Subject: Additional Information concerning the operation of Dresden Unit 2

SUPPLEMENTARY INFORMATION
for
DRESDEN UNIT 2
SPECIAL REPORT NOS. 8 AND 11

SUPPLEMENTARY INFORMATION
for
DRESDEN UNIT 2
SPECIAL REPORT NO. 13

SUPPLEMENTARY INFORMATION
for
DRESDEN UNIT 2
SPECIAL REPORT NOS. 2 AND 7

FIGURE 1

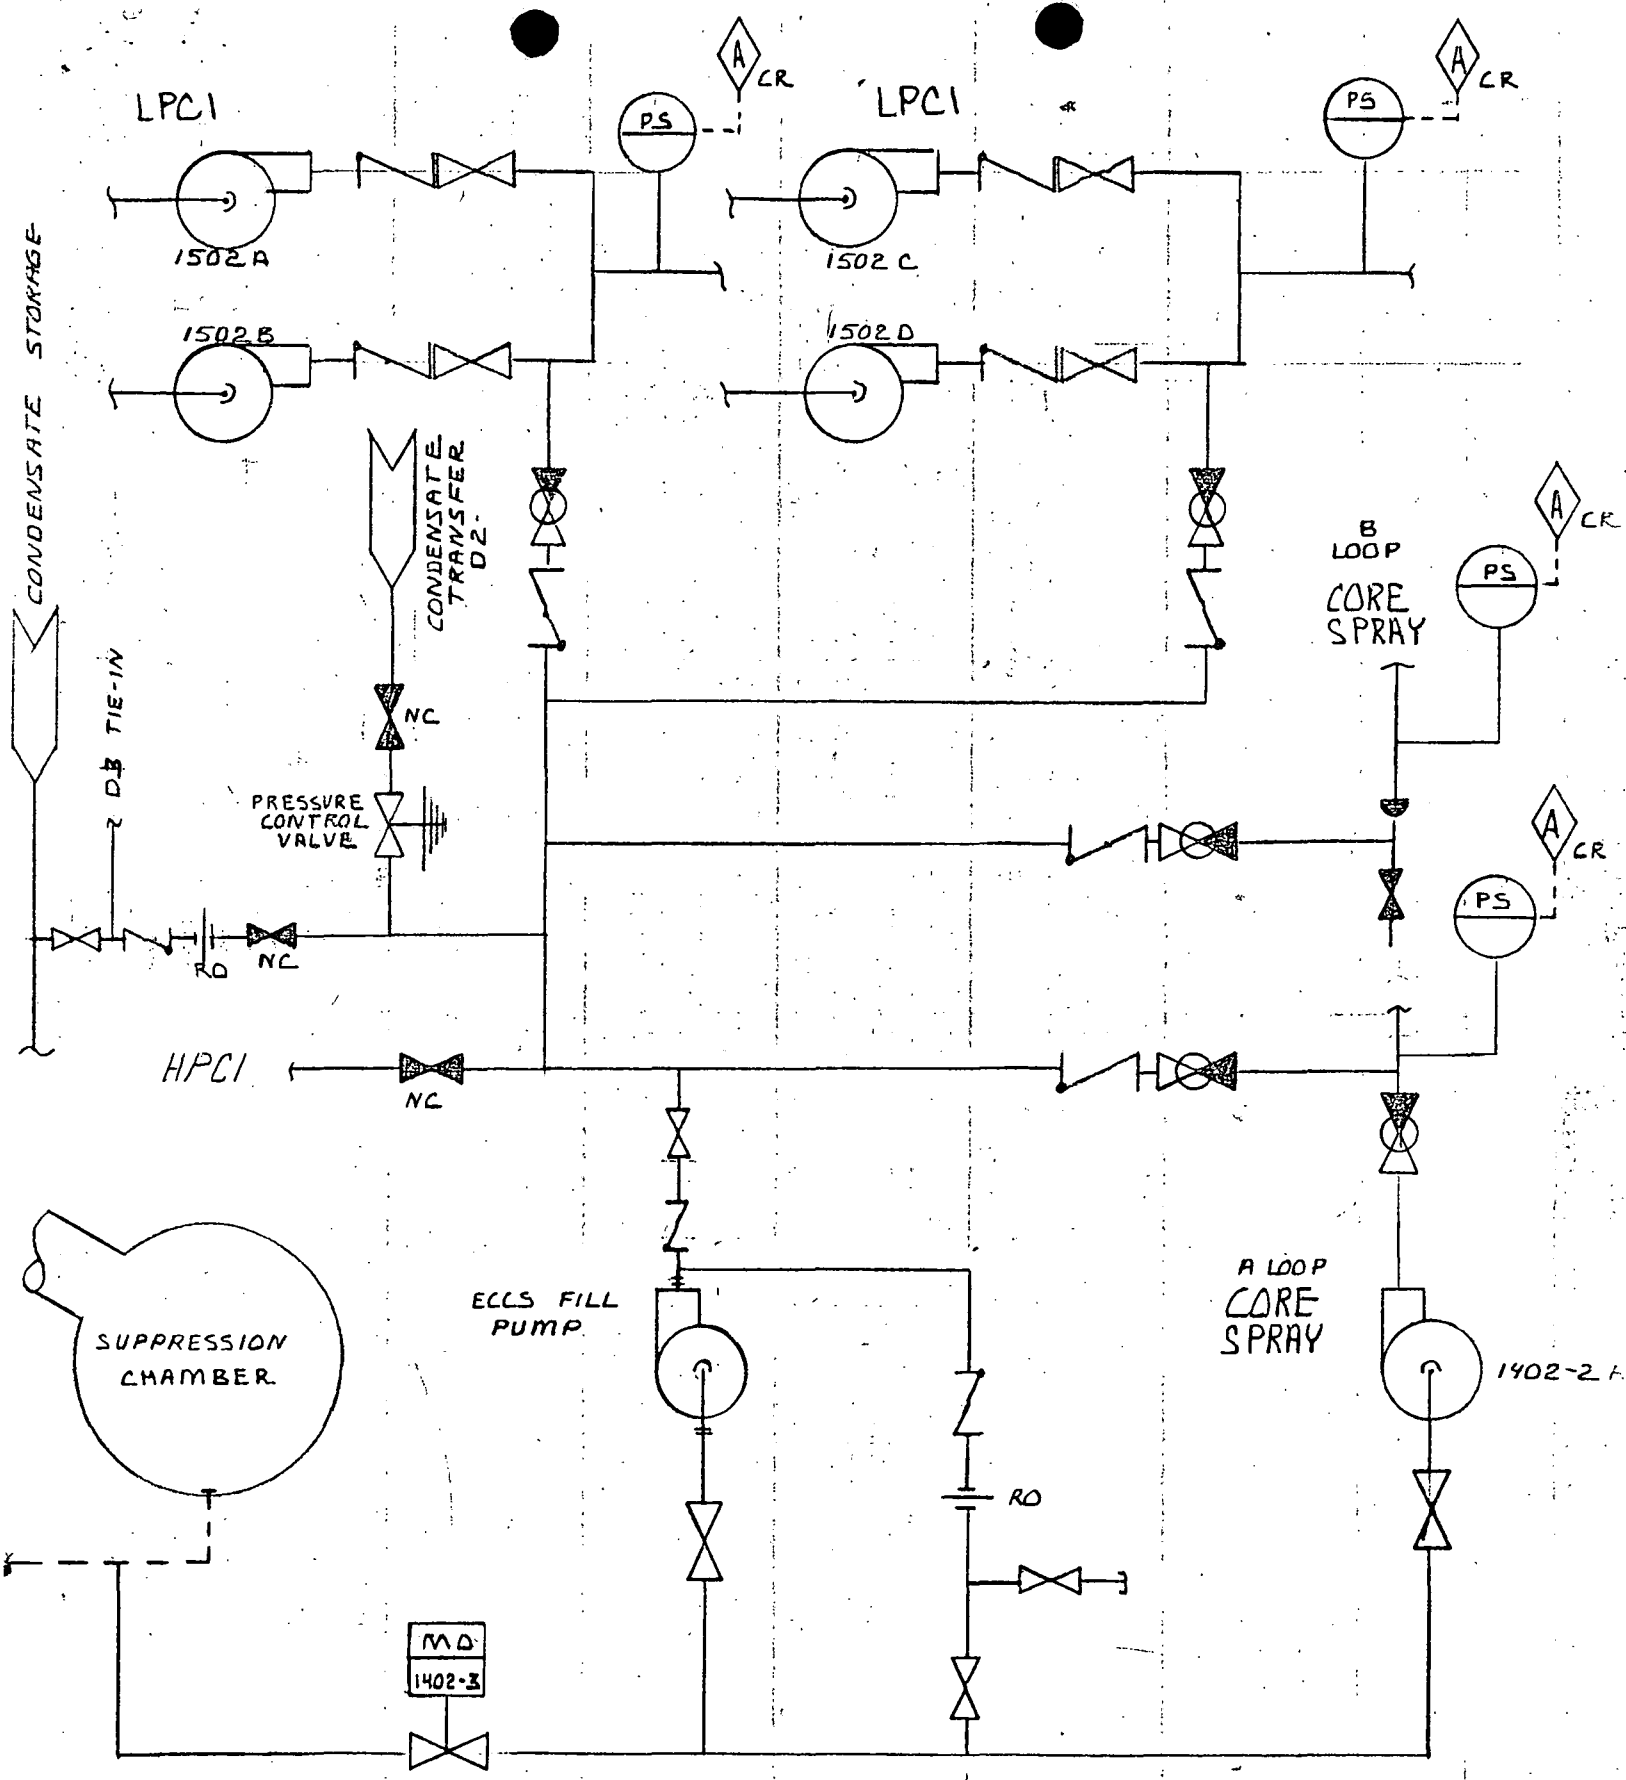
Corrective actions taken for the core spray water hammer problem and to prevent recurrence.

The ECCS Fill System (Figure 1) provides for a single continuously operating pump. The piping and valving are of the same quality as the ECCS supply header piping and valving. The ECCS Fill System utilizes the same fill points as previously utilized and the pump suction is downstream from the first motor operated valve on the torus header. The pump is rated at 50 gpm flow and 150 foot head (65 psi). Each core spray piping leg and each LPCI piping leg has an independent pressure switch which alarms in the control room if any leg loses pressure. These alarms are set at 50 psi, which is above the maximum static pressure (when the line is full) of 45 psi.

If the pump were unavailable due to repairs, the Condensate Transfer System can be valved back into operation and the temporary excess leakage through the valve again routed to radwaste. For this service, the condensate transfer water now will go through a pressure control valve so that the system pressure will not affect the AC interlock logic.

It should be emphasized that this system has alarms which will notify the operator if the jockey pump has stopped by setting the alarm above the static head. This allows the operator to valve in the original condensate system, thus giving further assurance that the lines are full.

FIGURE 1

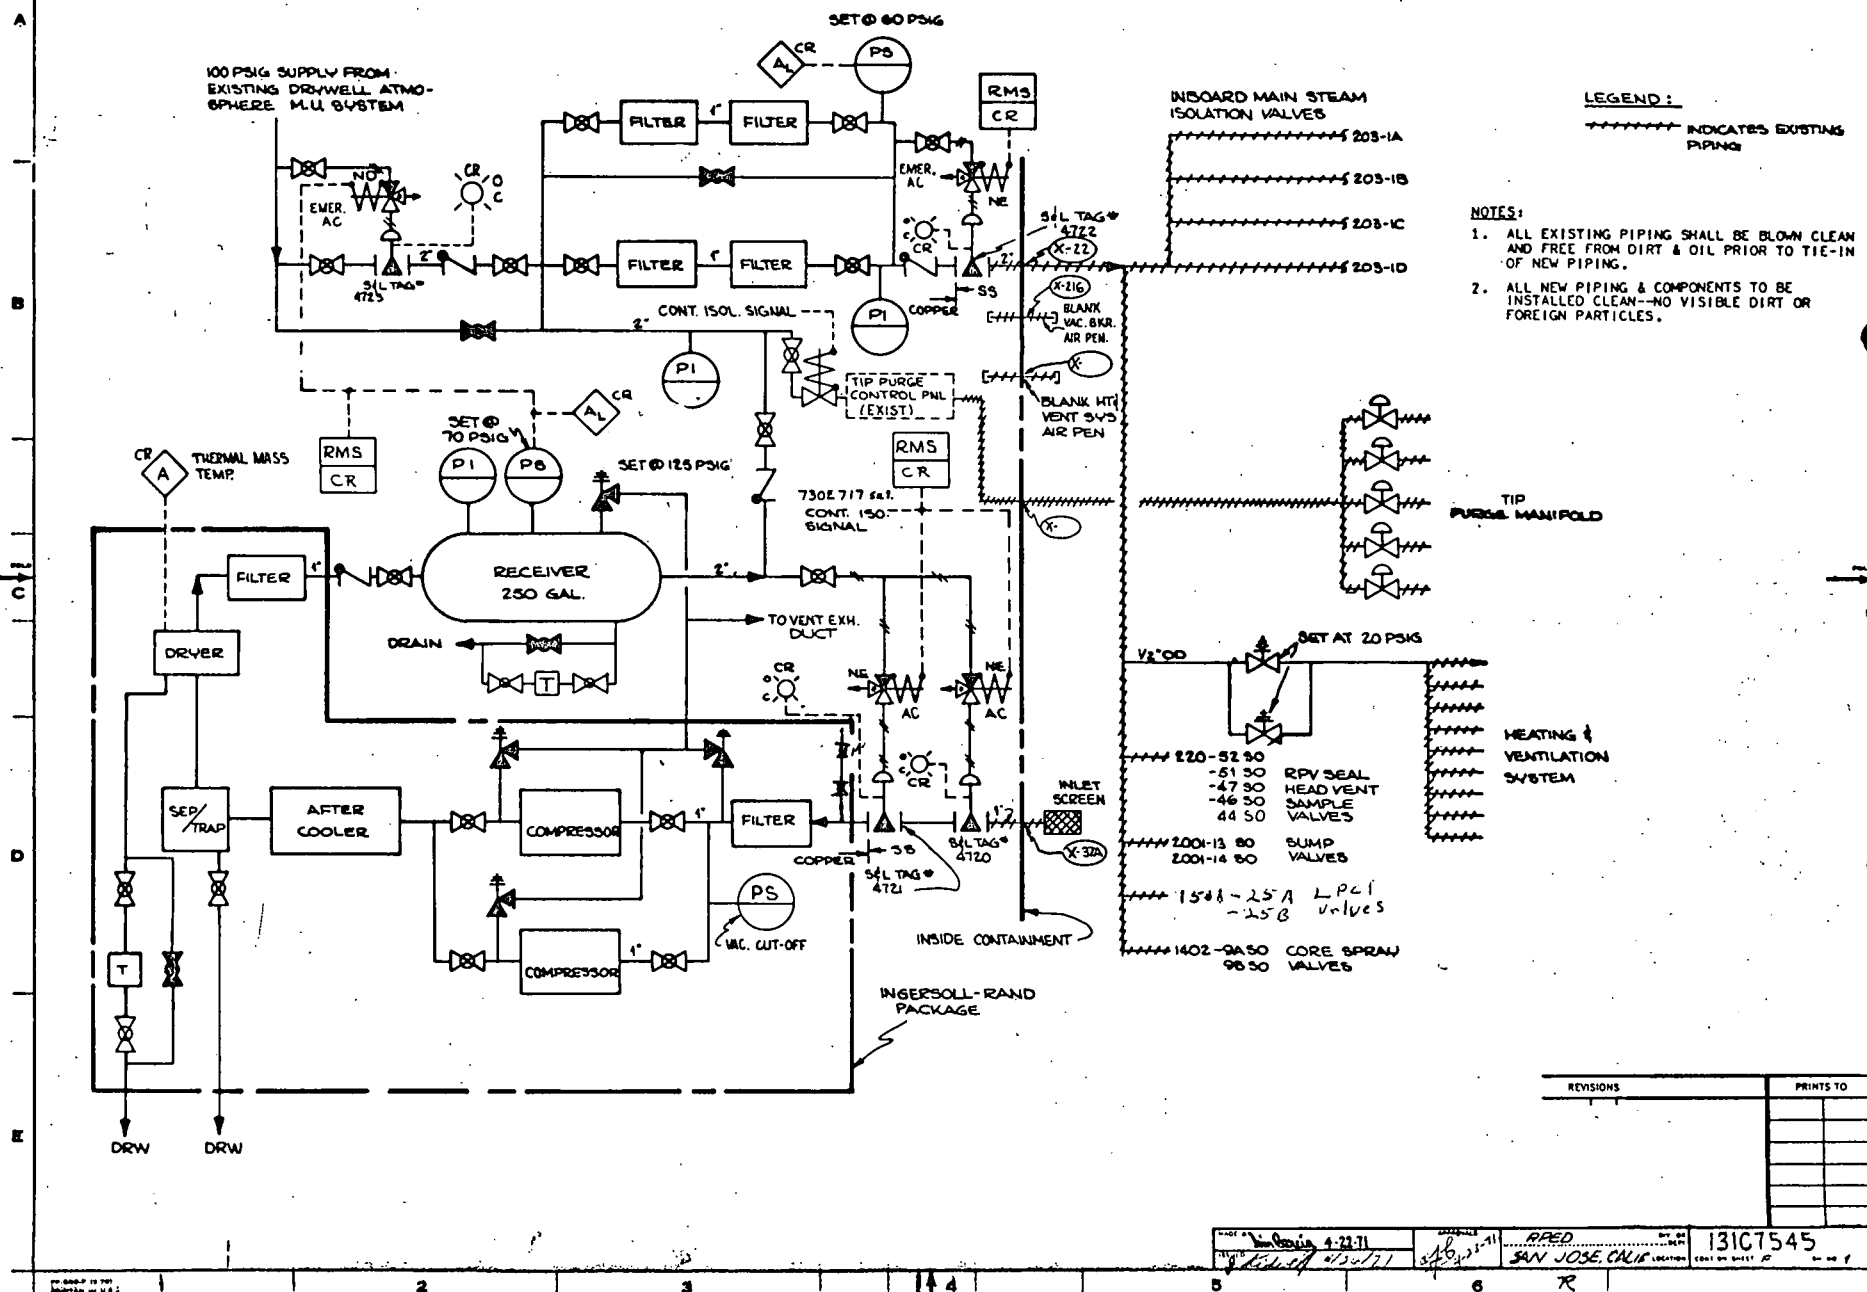
- I. Provide capacity, rating and design details of the Drywell Pneumatic Supply System.

The Drywell Pneumatic Supply System consists of a dual compressor unit, after cooler, moisture separator, dryer, receiver, filters and associated valves, piping, and instrumentation. A schematic diagram of the system is shown on the attached Figure 1.

Suction is taken directly from the drywell, filtered and compressed. The compressed gas discharging from the compressors passes through the after cooler, separator, dryer and after-filter to the receiver which is nominally held at 100 psig pressure. The gas then passes from the receiver through another set of after-filters to supply all of the pneumatic operated components inside the drywell. System and/or component design requirements are as follows:

FIGURE 2

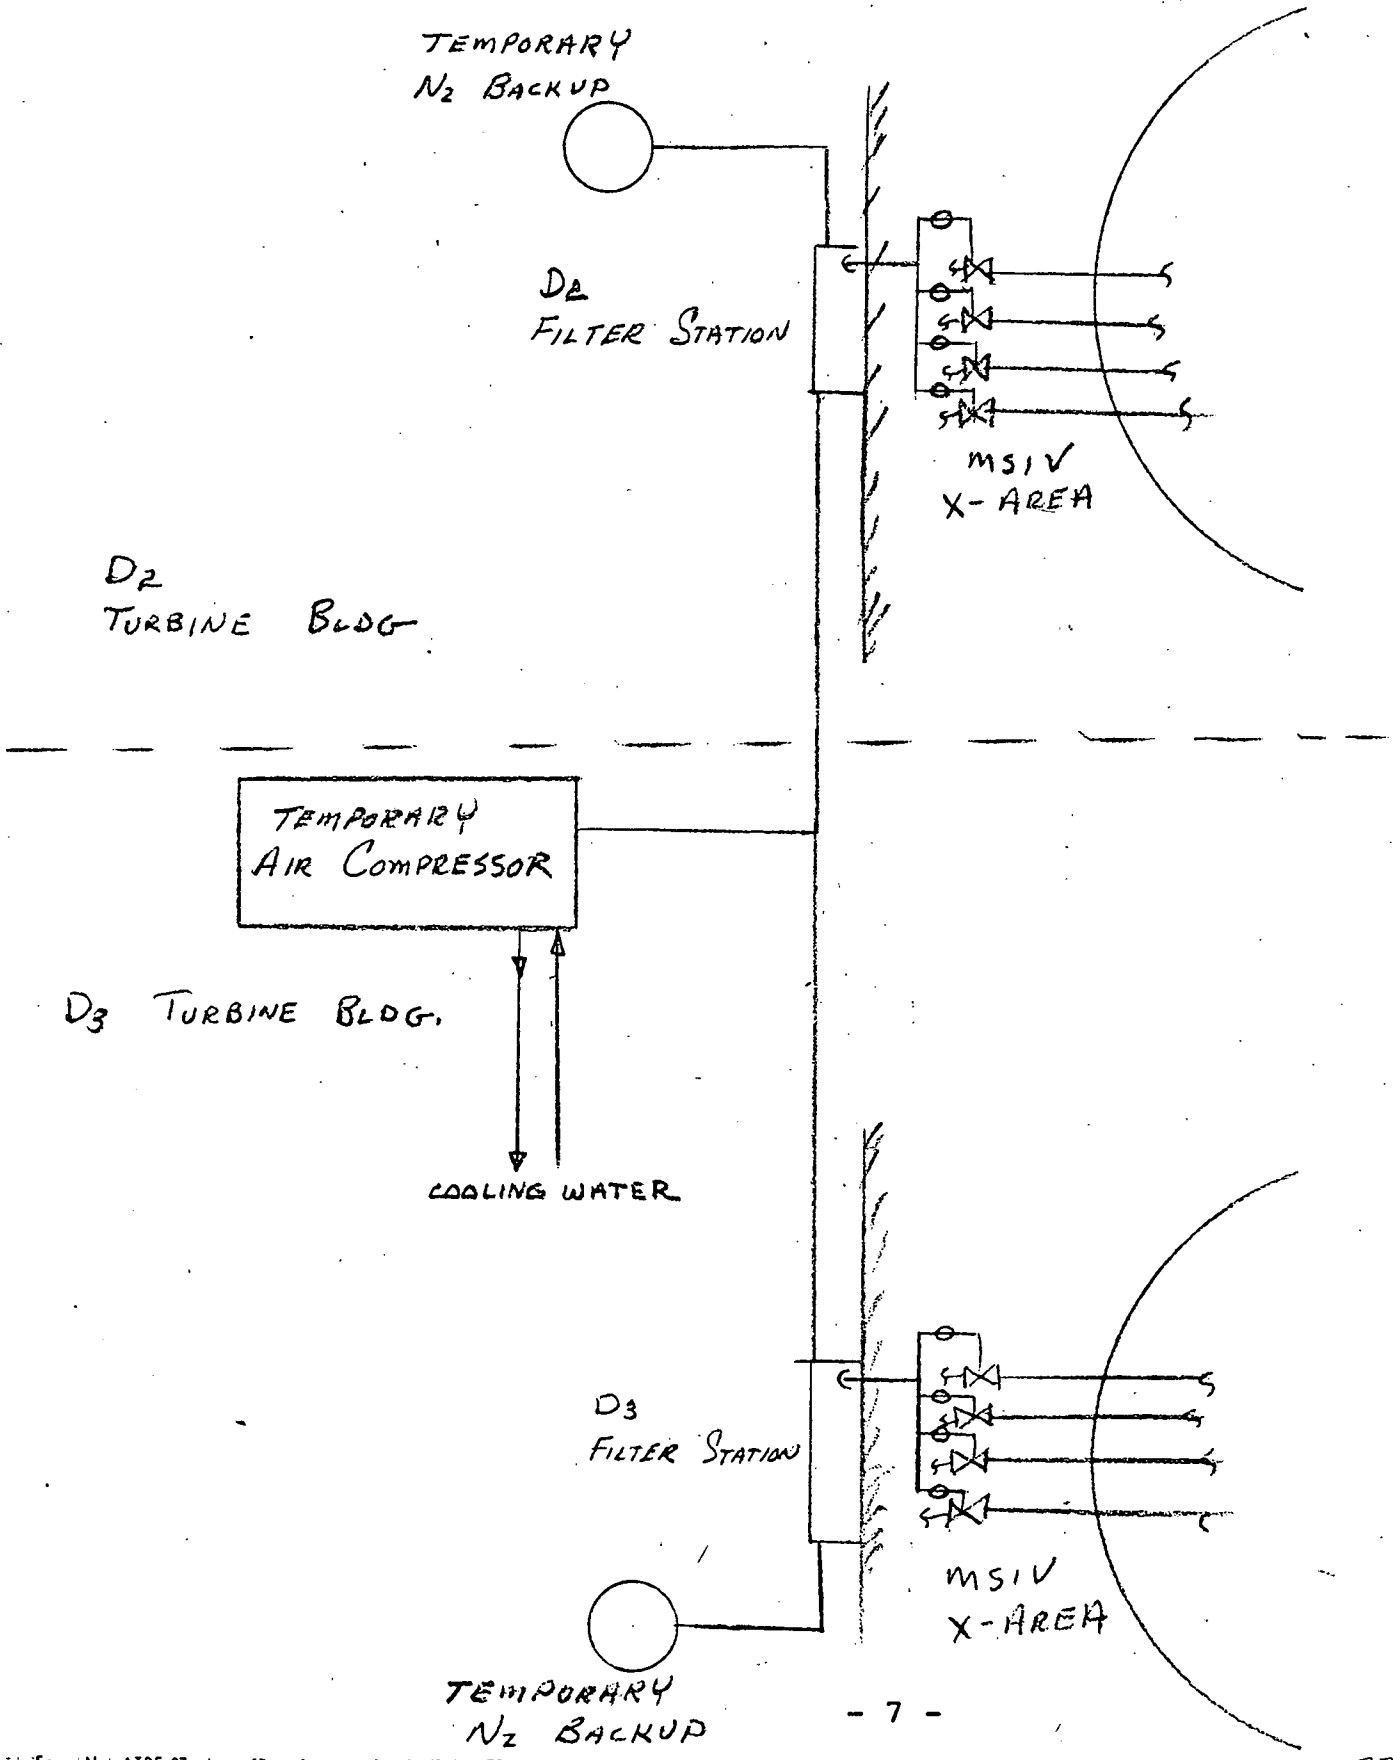
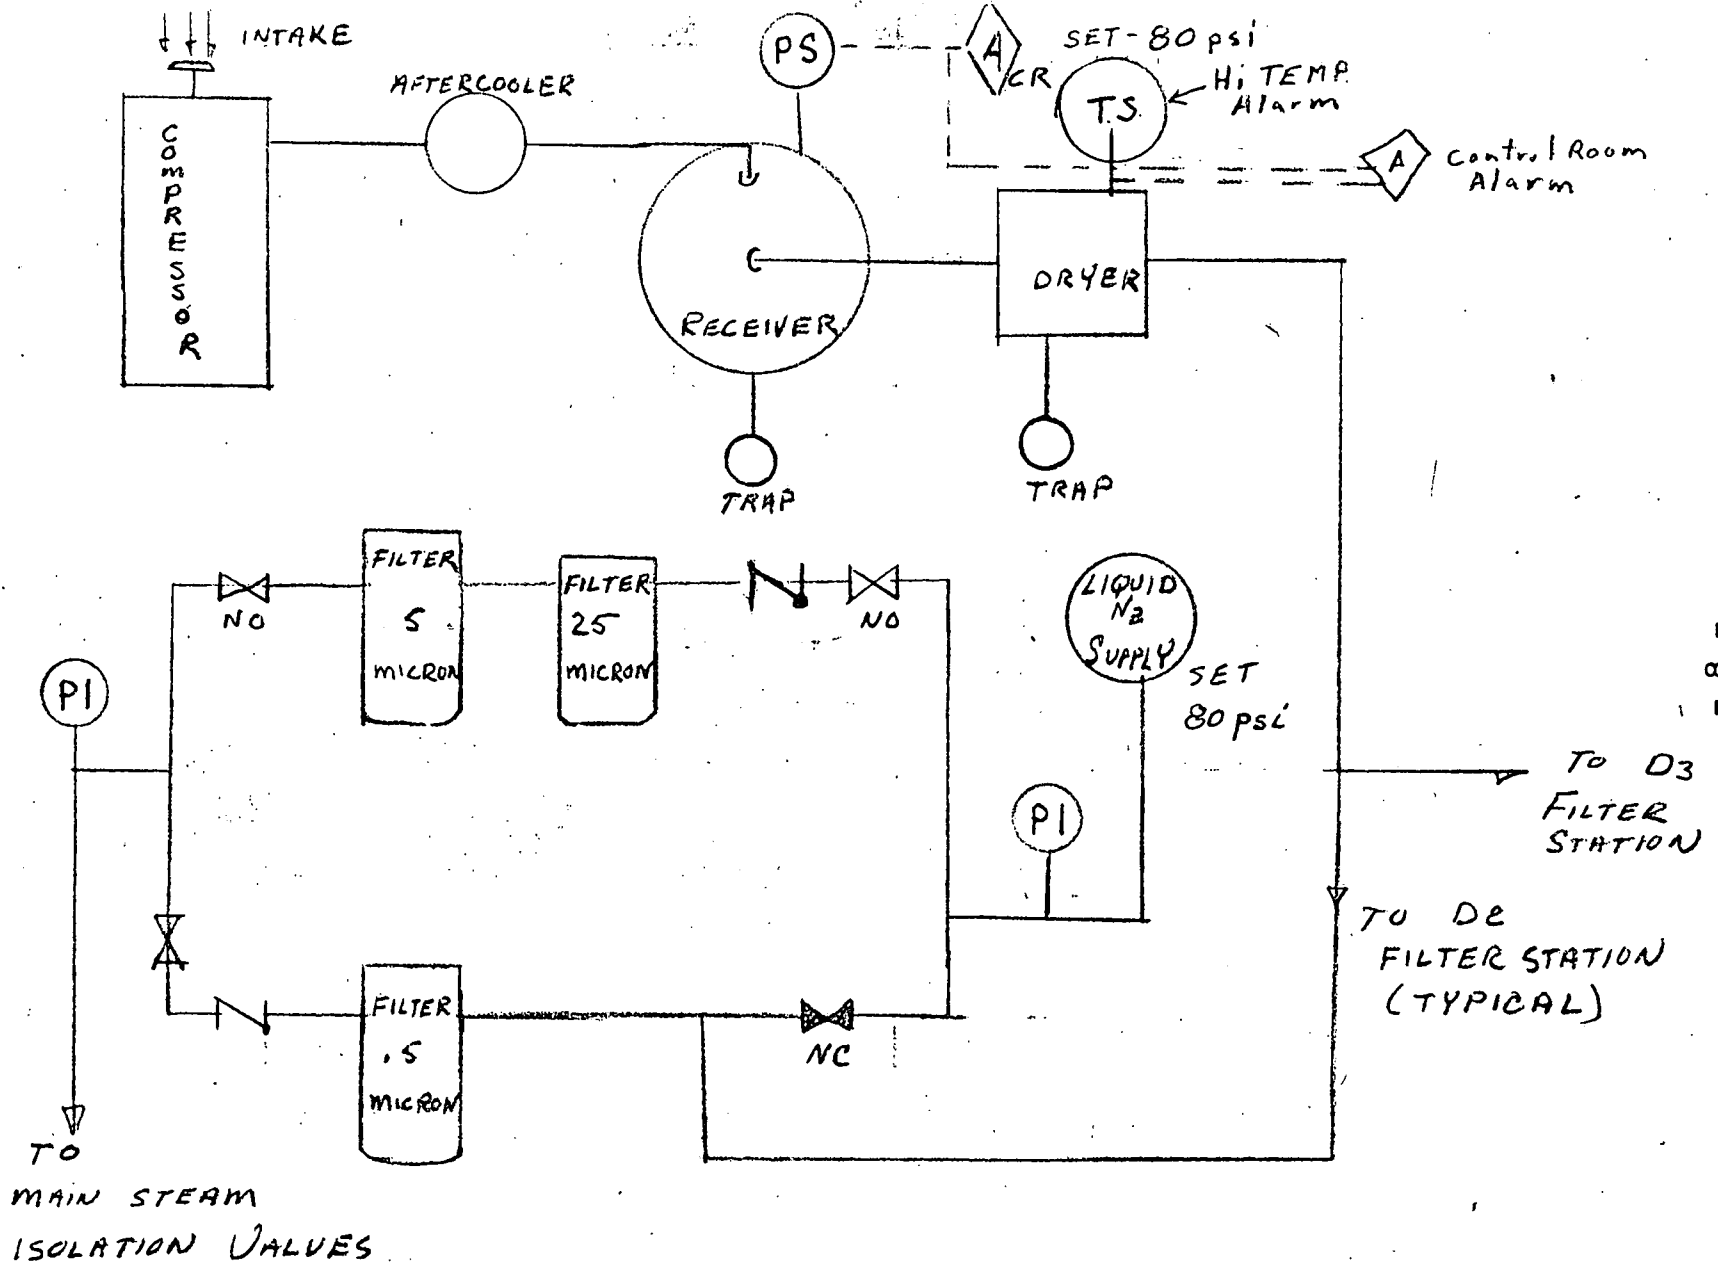
- II. Provide description of the interim and final design for the instrument air supply for the outside main steamline isolation valves.

2. Interim Action for Equipment Outside of Primary Containmentment. The most critical equipment outside of the Primary Containmentment with respect to Contaminated Air Supply are the Outboard Main Steam Line Isolation Valves. During the refueling outage the Station Instrument Air Supply has been removed from actuator assemblies and replaced with a temporary supply system served by a small air compressor unit. This system consists of an oil-free compressor unit, after cooler, receiver, dryer, filters, and associated valves, piping, and instrumentation. A schematic diagram of this system is shown on Figure 2 and 3.

Suction is taken from the Turbine Building and discharged through a filter station to both the Dresden-2 and Dresden-3 X-area Main Steam Isolation Valves. In order to maintain maximum plant operability and flexibility, a temporary backup supply of nitrogen is provided from a bottled liquid source. This is the same system as described in the March 17, 1971 Special Report for Dresden-2, Report No. 7.

The compressor is a single stage, water cooled non-lubricated cylinder type which is rated at 9.4 acfm dry, oil-free air at 100 psig. The compressor is mounted on the 80 gallon receiver tank along with a water cooled after cooler.
